BRANCH SERVICE MEMO NO. 916CS

DEALER SERVICE MEMO NO. 604

SUBJECT: Connecting Rod #A-63477-B and A-67745-B
supersede A-63477-A and A-67745-A

HOLE LOCATION CHECKS

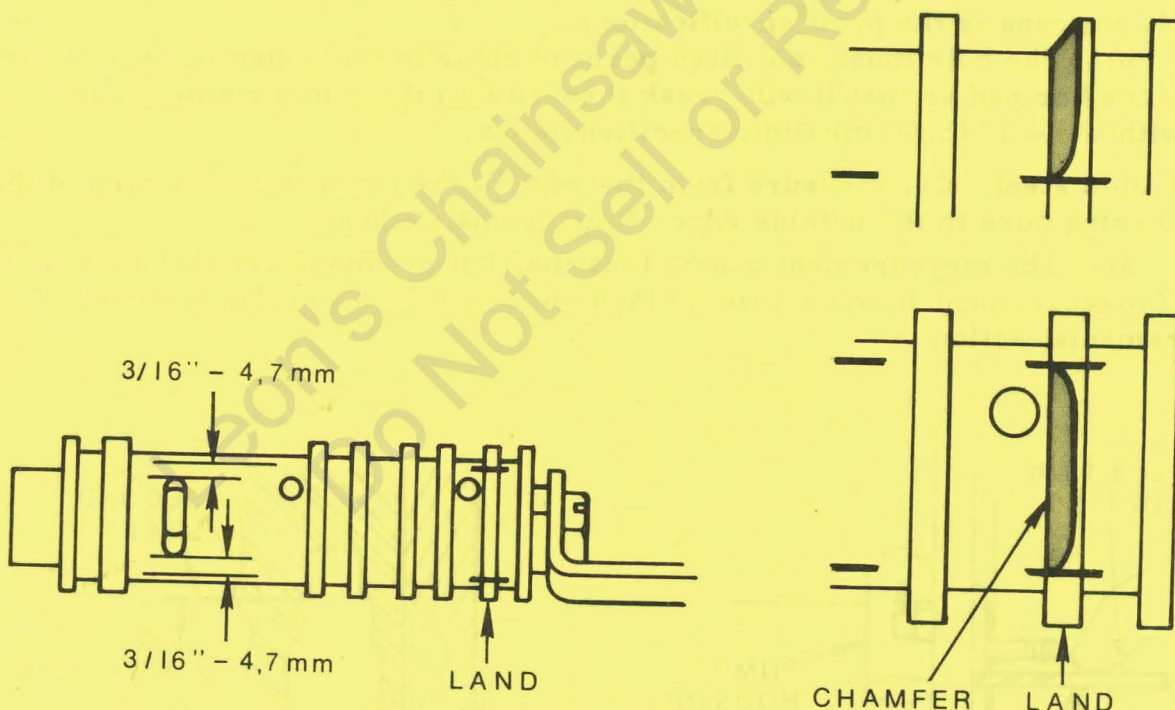
We have determined that some failures of 350 automatic oil pumping are the result of improper location of the oil discharge hole in the pump housing wall, especially true in cold weather. The pump discharges properly when the hole is open to the front chamber between the two front O-rings. But when the hole is over the front O-ring land, discharge is impeded. This memo tells you how to check for proper hole location, and what to do to restore pumping if the hole is wrongly located.

1. Push a 1/8" or 3,1 mm drill into the oil discharge hole in the guide bar pad to check that it is drilled correctly.
 - a) The hole can be drilled upward at an angle of up to 13 degrees. (13 degrees is the print specification).
 - b) The hole must be drilled perpendicular to the mounting face of the guide bar pad so that it will break through into the pump compartment within the 2" (5,0 cm) Dim. specified below.
2. With a steel rule, measure from the edge of the second rise or step of the housing bore to the outside edge of the discharge hole.
 - a) The measurement can be less than but not more than 2" (5,0 cm). If measurement is more than 2" (5,0 cm) the hole is too far forward. Take remedial action.

One course of action is to make a permanent cure by replacing the crank case with one having a properly located oil discharge hole. If the customer is unwilling to wait for rebuild, you can modify the pump body as shown. However, if the modified pump body is ever replaced, the replacement body must be reworked in the same manner.

1. Remove the O-rings from the pump body.
2. Remove pump plunger and gear.
3. Measure and mark the body at two points. Each point should be $3/16$ (4,7 mm) inch from one end of the cam slot. Measure parallel to these points and mark the wall of the front land of the forward pump compartment for chamfering.
4. Chamfer the marked section of the land to the approximate cross section shown here. Clean the pump body carefully. Coat pump plunger with clean light oil and install in pump body. Reassemble into crank case housing.

SUBJECT: Wire Harness Routing 1975 T-10, T-13, T-16

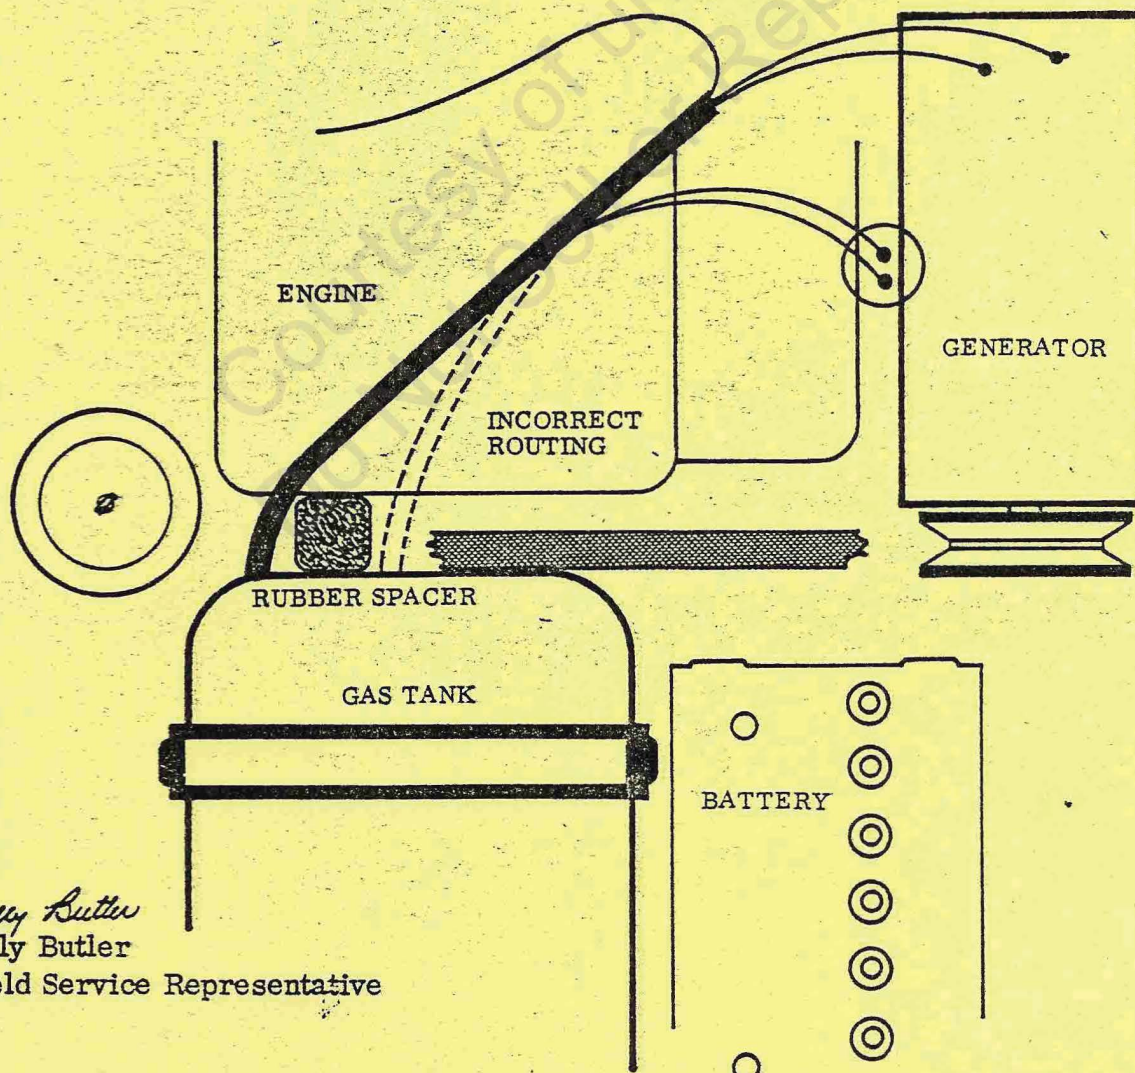
- 1. Remove LM-01769-12 Clips, Ref. (B)
- 2. Install LM-01769-64 Guide, belt, using 2 LM-09193-13 cap screws and 2 81235 lock nuts and mounting the cap screws through the holes provided in frame at Ref. (G).
- 3. Remove throttle cable from engine and clamp, Ref. (C).
- 4. Pull throttle cable through frame and re-route wiring harness next to frame and secure to LM-01769-64 guide, belt at Ref. (D) and throttle cable, Ref. (E), using 12298 tie, cable.

- 5. If wiring harness is too short to reach, cut and splice wires as needed.
- 6. Replace throttle cable, securing at clamp, Ref. (C) and engine.
